Developer Services
Southern Water
Sparrowgrove House
Sparrowgrove
Otterbourne
Hampshire
SO21 2SW

Your Ref
FG/159/18/PL
Our Ref
PLAN-024957
Date
07/11/2018

Proposal: Two-storey extension to the existing Cafe in order to provide increased internal seating, multi-purpose space, with improved service & food preparation area, disabled access & bike storage.
Site: The Bluebird Café, South Drive, Ferring, BN12 5QU.
FG/159/18/PL

Southern Water MapGuide Browser

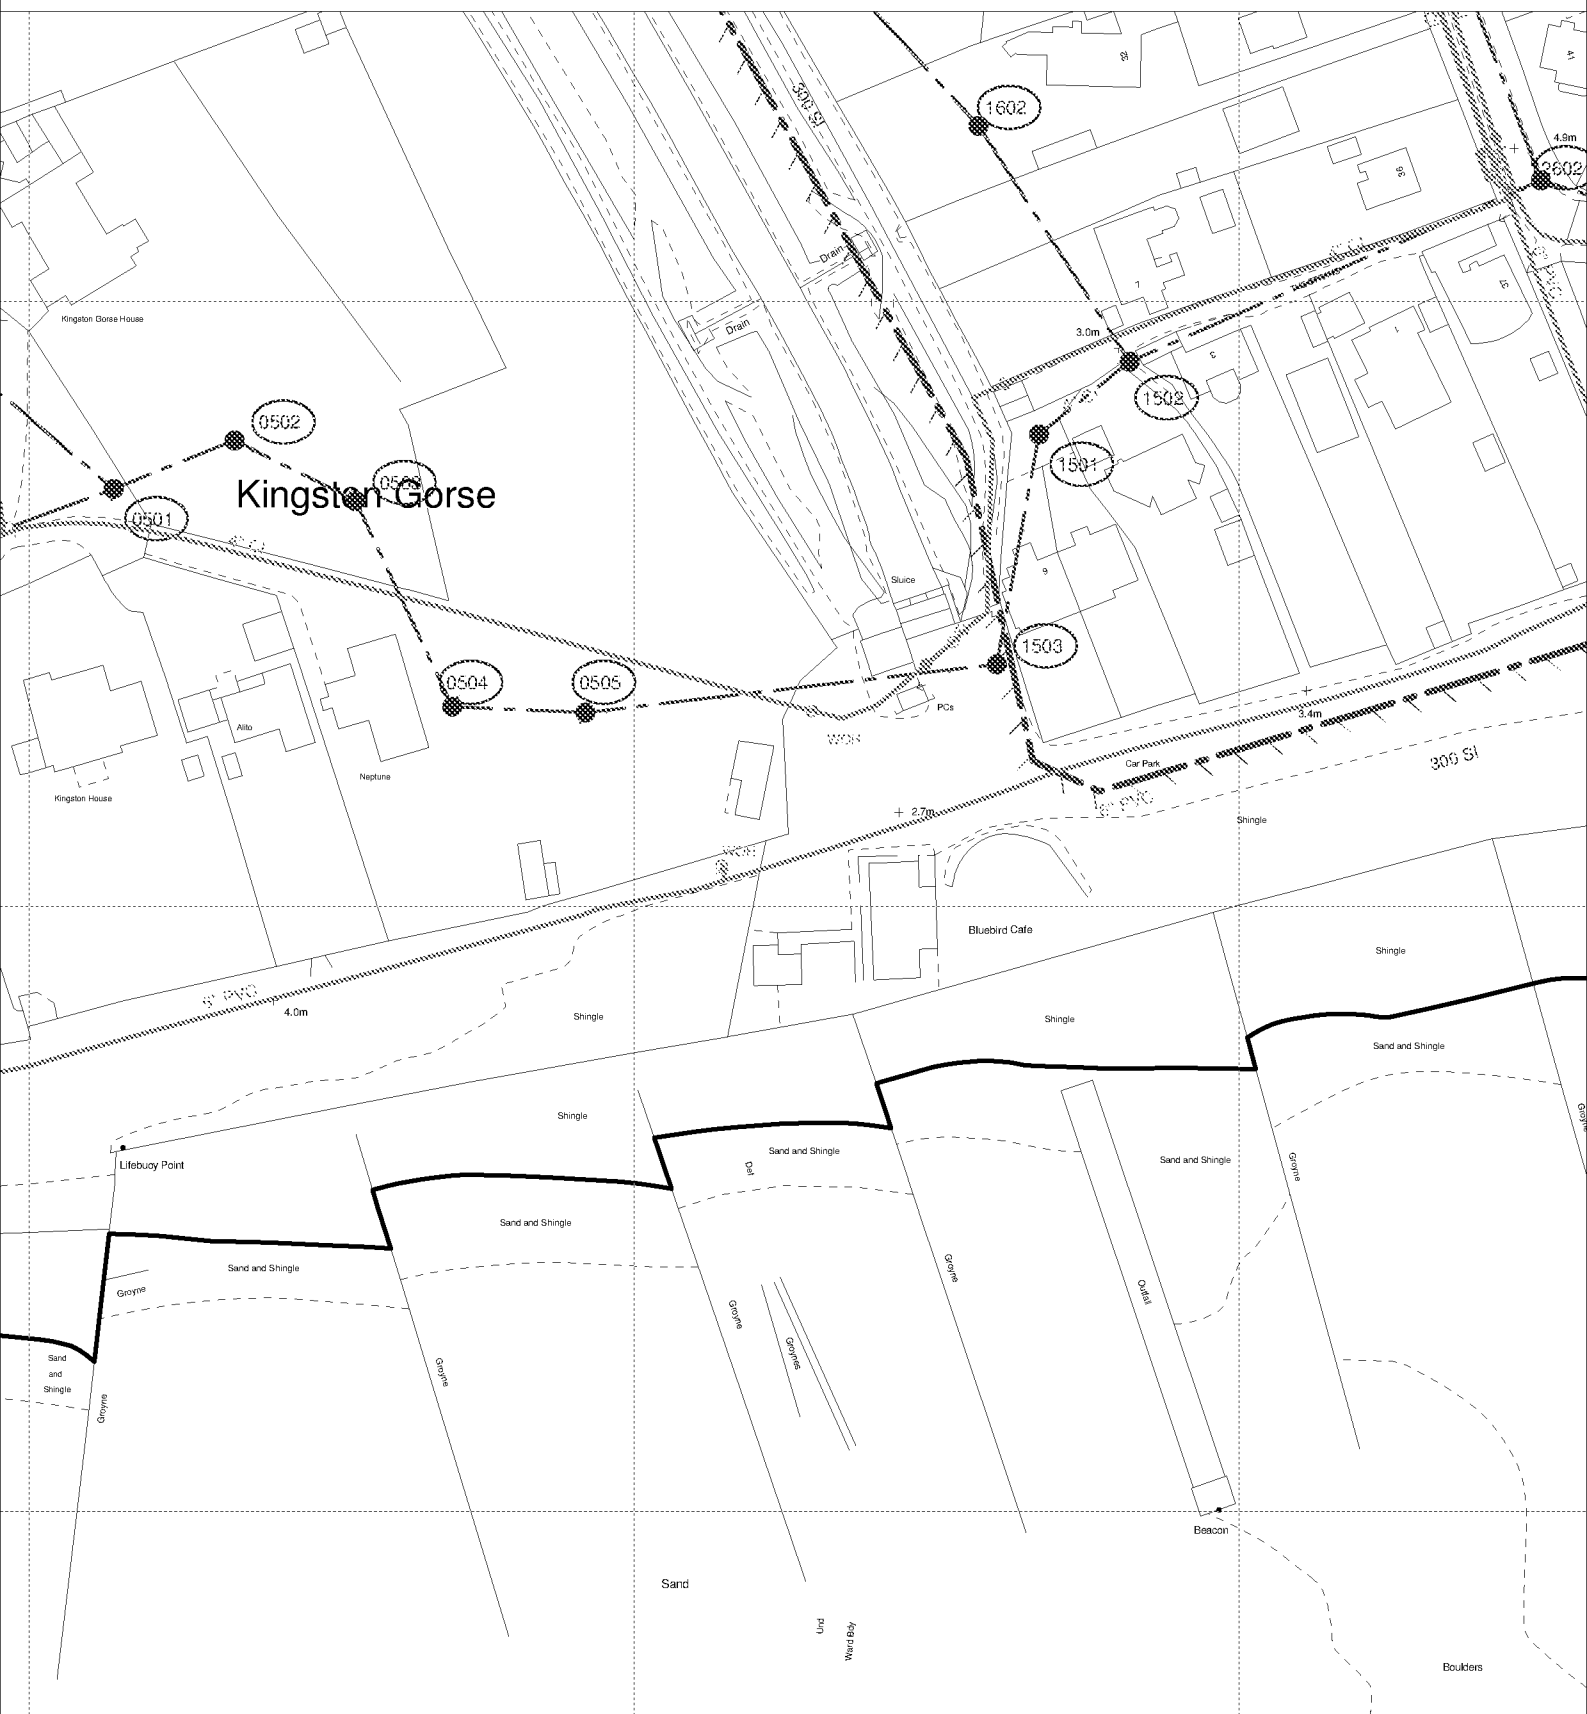
Please find attached a plan of the water main records showing the approximate position of a public water distribution main within the site. The exact position of the public water main must be determined on site by the applicant before the layout of the proposed development is finalised.

All existing infrastructure, including protective coatings and cathodic protection, should be protected during the course of construction works. No excavation, mounding or tree planting should be carried out within 6 metres of the public water main without consent from Southern Water.
